FEBRUARY 2021

Specification change: GE1A series electronic timers

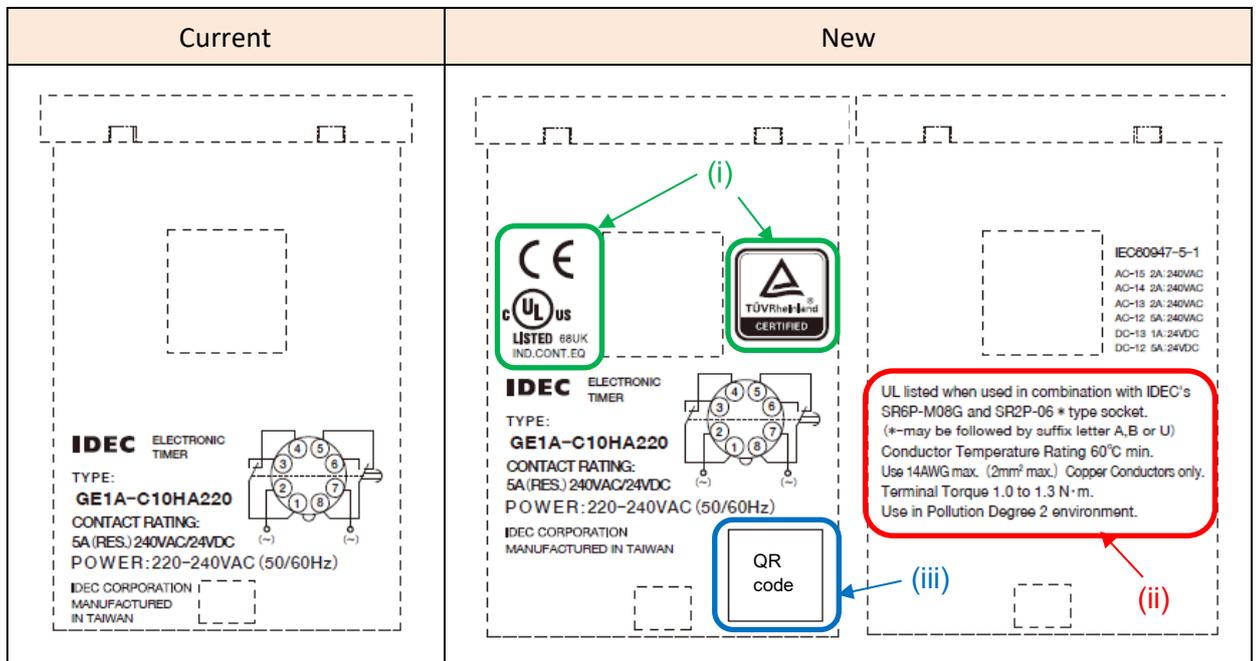
a) For the following part numbers, the markings on the products will have the following changes:

- (i) Update of TUV marking
- (ii) Addition of descriptions regarding the standard certifications
- (iii) Addition of QR code

Current	New
<p>Current marking layout for GE1A-C10HA220. Includes CE, UL US LISTED 68UK IND.CONT.EQ, IEC60947-5-1 ratings, and technical specifications.</p>	<p>New marking layout for GE1A-C10HA220. Changes include: (i) Updated TUV marking to TÜV Rheinland CERTIFIED; (ii) Addition of conductor temperature rating, wire gauge, and torque specifications; (iii) Addition of a QR code.</p>
